1986 - 1987 Corvette: Service Bulletin: Clutch Master Cylinder Push Rod Bushing

Subject: Clutch Master Cylinder Push Rod Bushing

Model Year: 1986 - 1987 Corvette with Manual Transmission

Bulletin No: 87-114, Section 7C

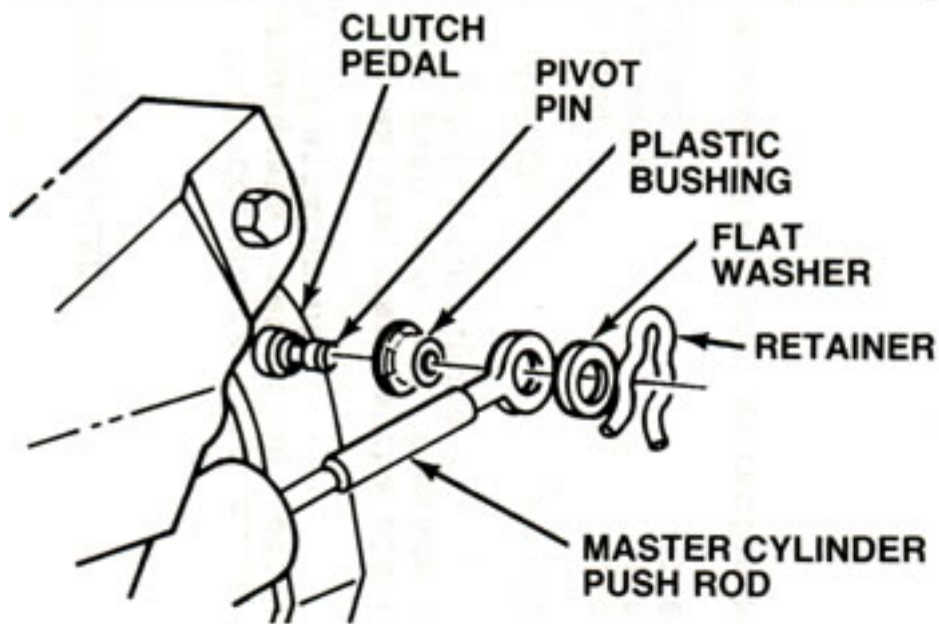
Some 1986 or 1987 Corvettes with manual transmissions may experience inadequate retention of the clutch master cylinder push rod attachment.

If the condition exists, remove the plastic bushing from the master cylinder push rod and replace with the following service parts. (Refer to Figure 1):

| DESCRIPTION | PART NUMBER |
| Bushing | 14080233 |
| Flat Washer | 120395 |
| Retainer | 148149 |
